DESIGN MEMORANDUM
13
COOPER RIVER REDIVERSION PROJECT
LAKE MOULTRIE AND SANTEE RIVER
SOUTH CAROLINA

COOLING WATER
FACILITIES

SADEN-GP (15 Oct 80) 1st Ind
SUBJECT: Cooper River Rediversion Project, Lake Moultrie and Santee
River, South Carolina, Design Memorandum 13 - Cooling Water
Facilities

The Cooling Water Facilities Design Memorandum is approved subject to sub-
mission of a detailed estimate on spray canal system and the following comments:

Figure 1

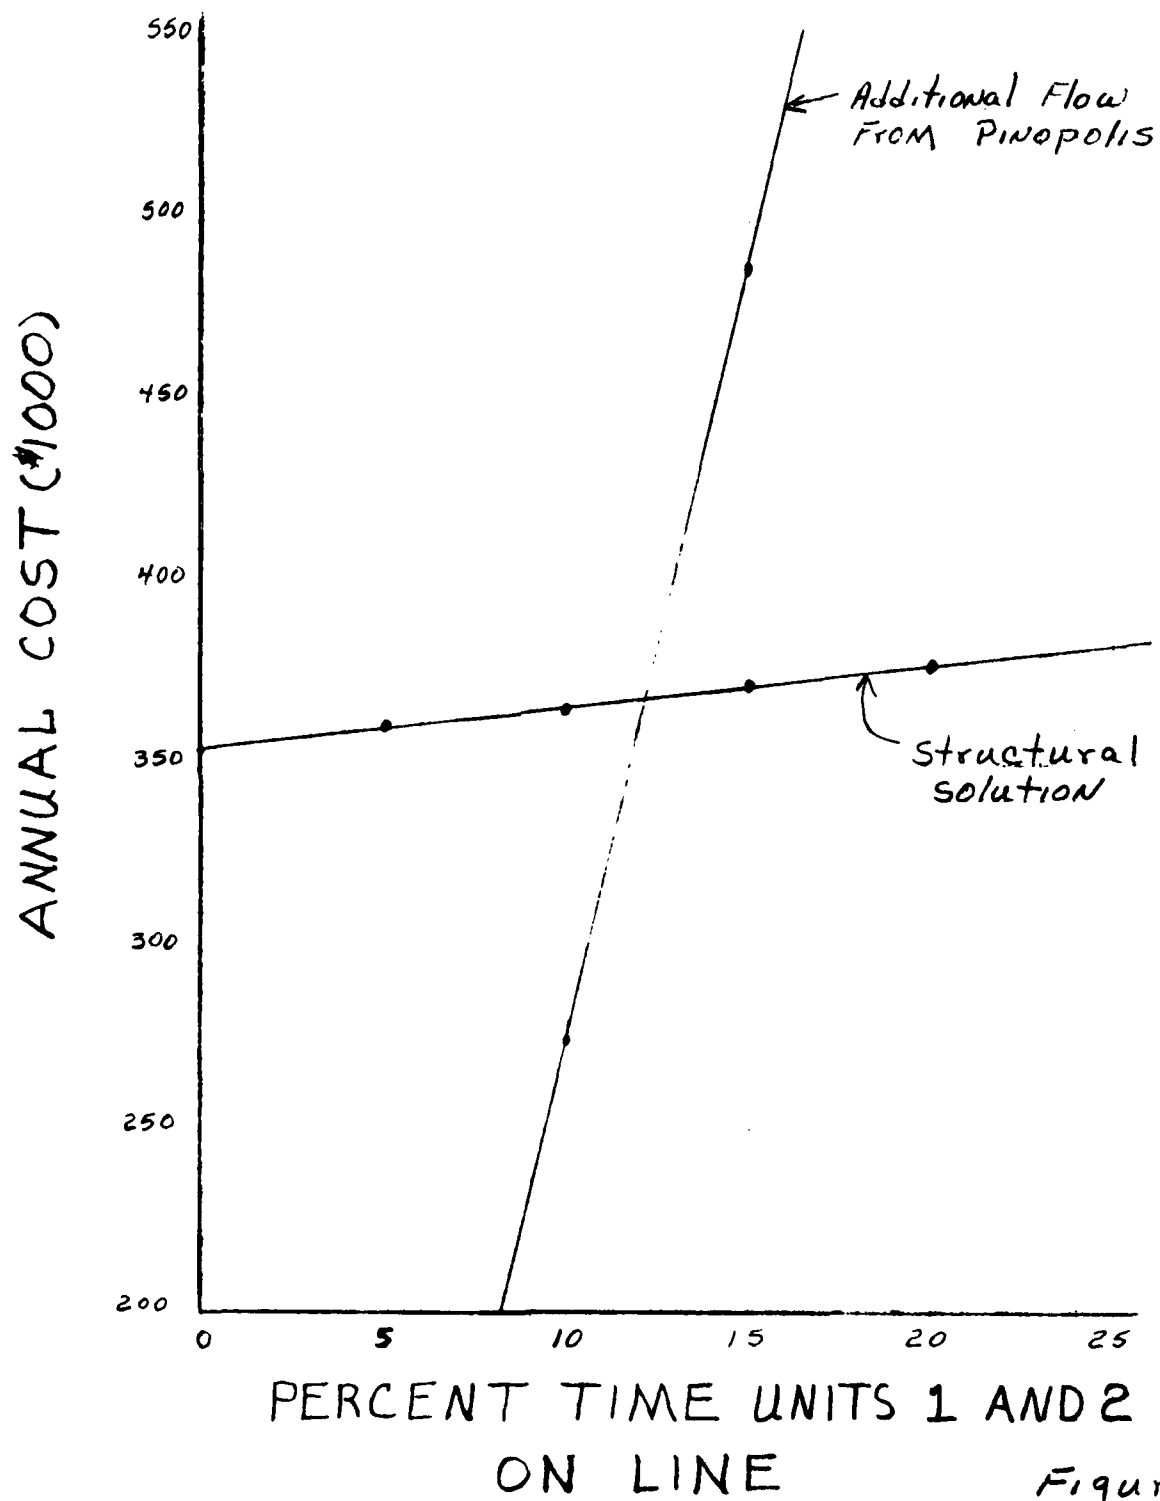
e. Page 6, paragraph 22. It should be explained why Table 1 and Table
2 differ and why Table 1 values are selected for the analysis of alternatives
shown in Figure 1.

COOPER RIVER
SHOWING
PREDICTIONS
COMPLETED

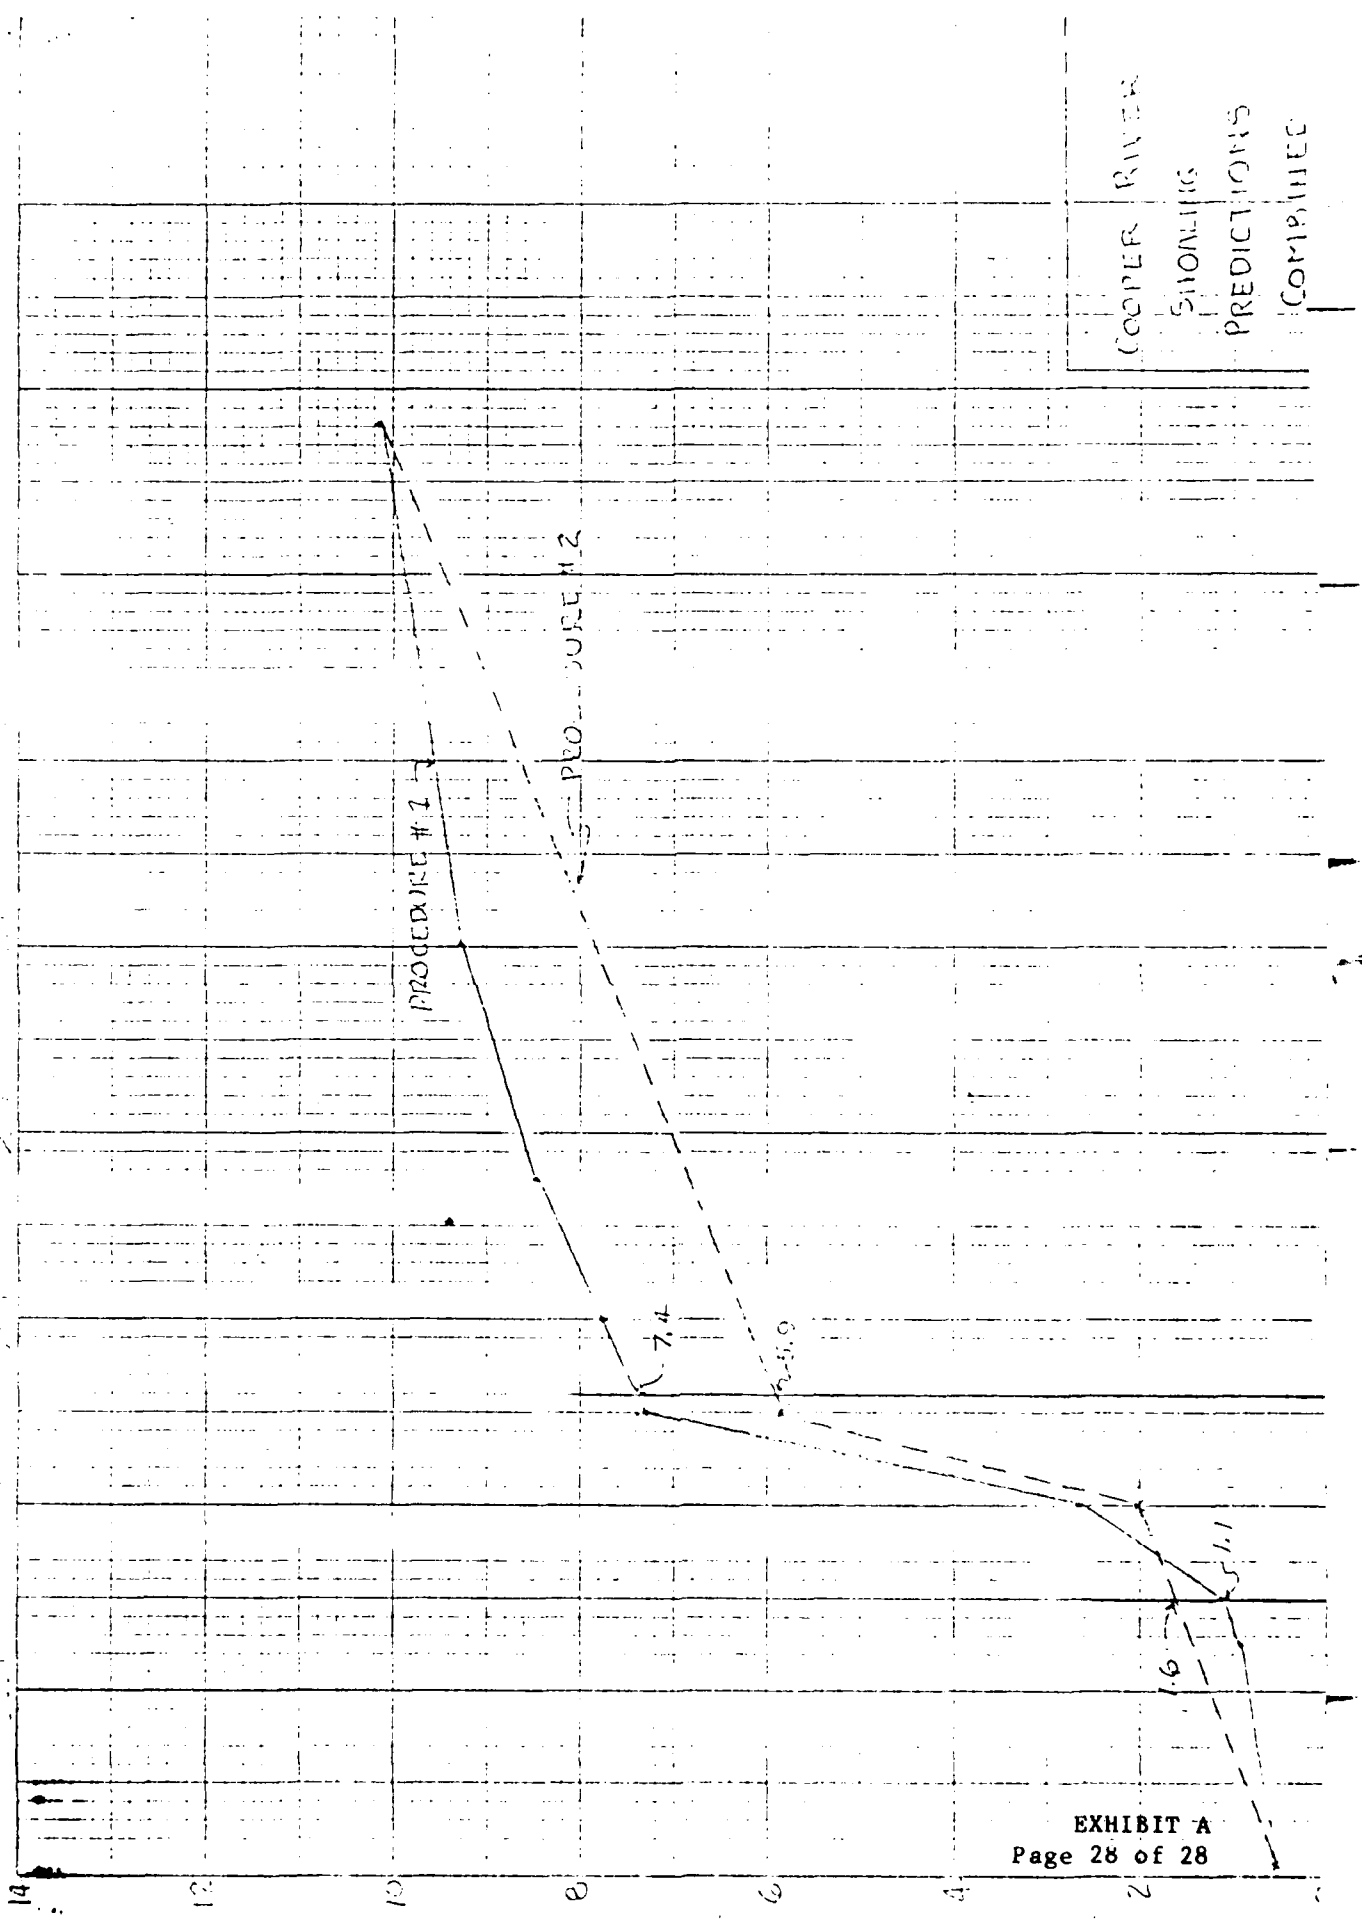
c. Page 5, paragraph 20. Figure 19 is not identifiable in Exhibit A
due to poor reproduction. We assume Figure 19 is on pages 26-28 of Exhibit
A. However, the absicxa and ordinate of these graphs are not legible.
Clarify.

DESIGNED BY B. RICHARDSON DATE 10/31/78 SHEET NO. 1 PAGE NO. 1
 CHECKED BY RA. MAXS DATE 10/12/78 OF 1 JOB NO. 7238-02
 REVIEWED BY _____ DATE _____ SUBJECT: CIRCULATING WATER SCHEMATIC
 APPROVED BY _____ DATE _____ SPRAY CANAL ALTERNATIVE

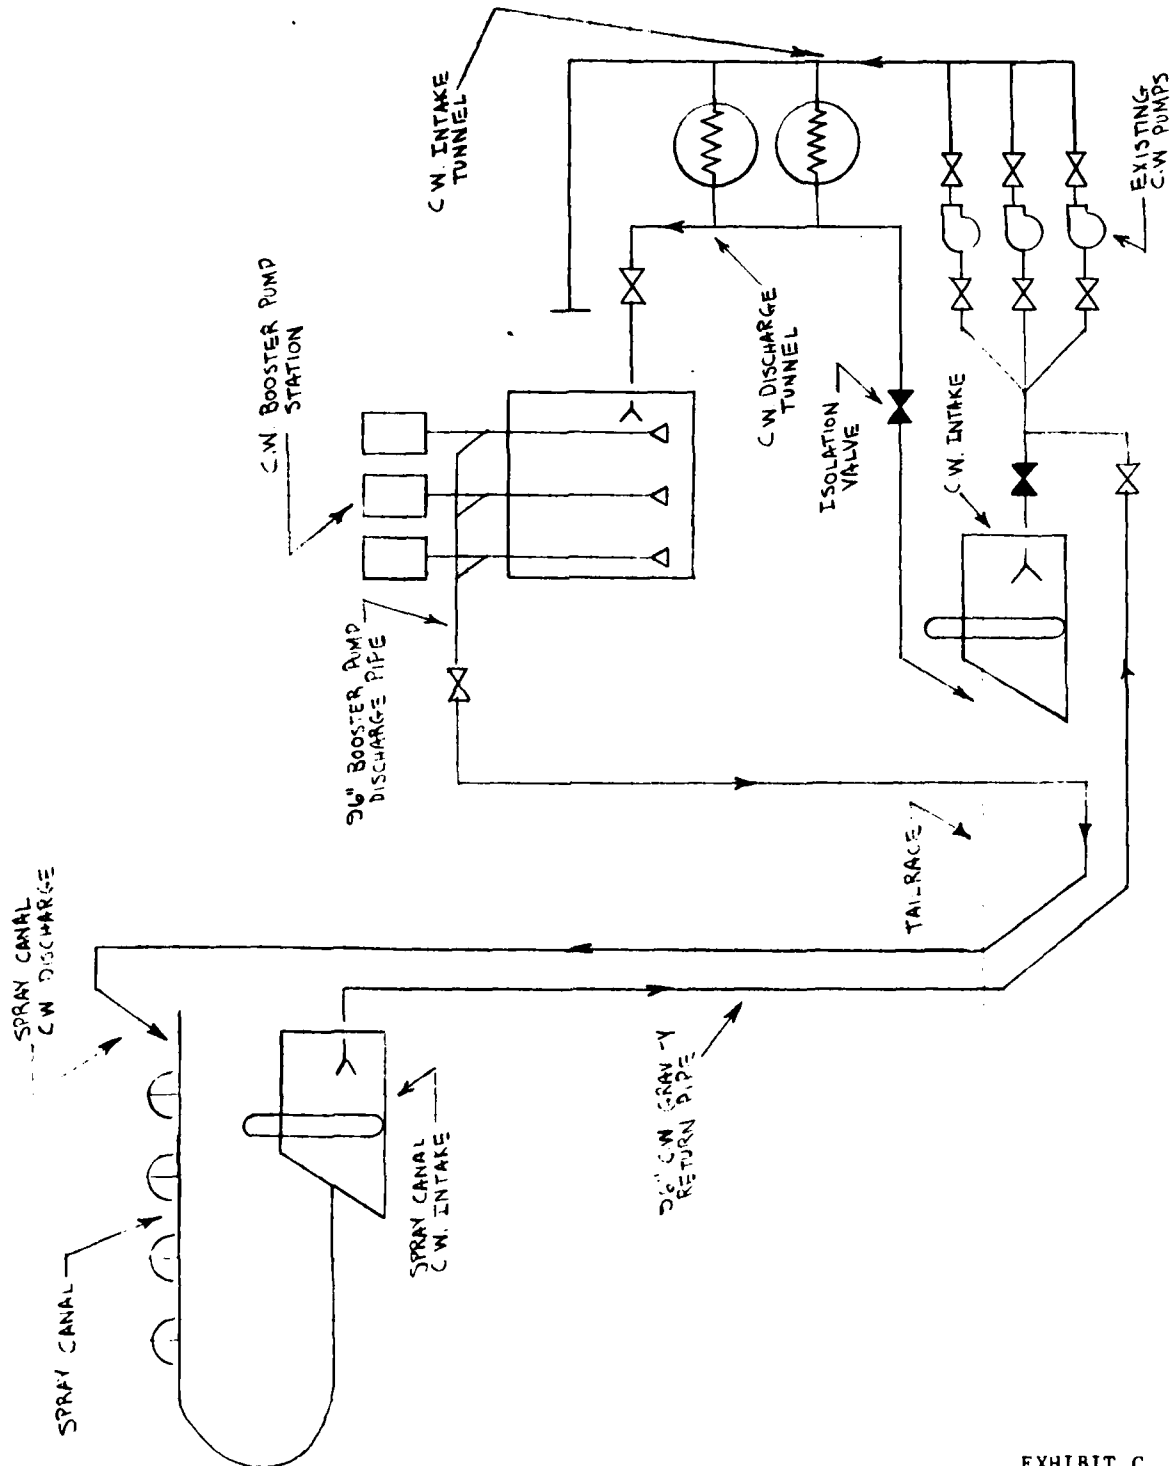
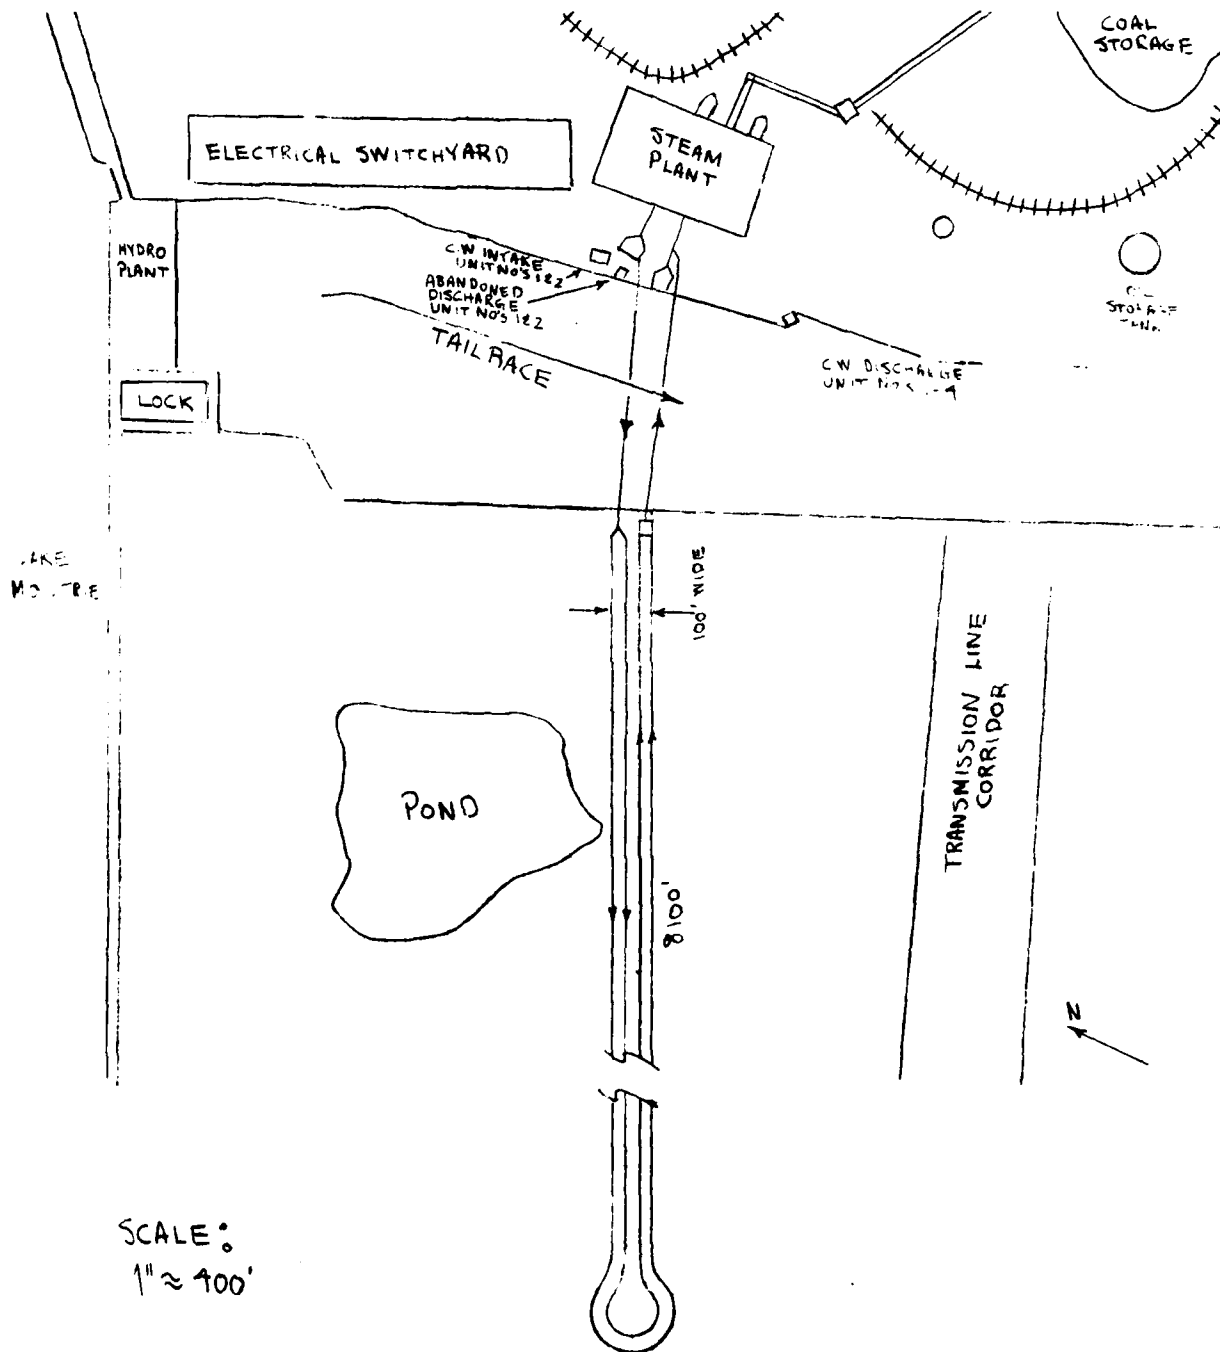
j. Page 14, paragraph 36. The details given in this paragraph do not agree with those shown on exhibit C, page 6. Clarify.
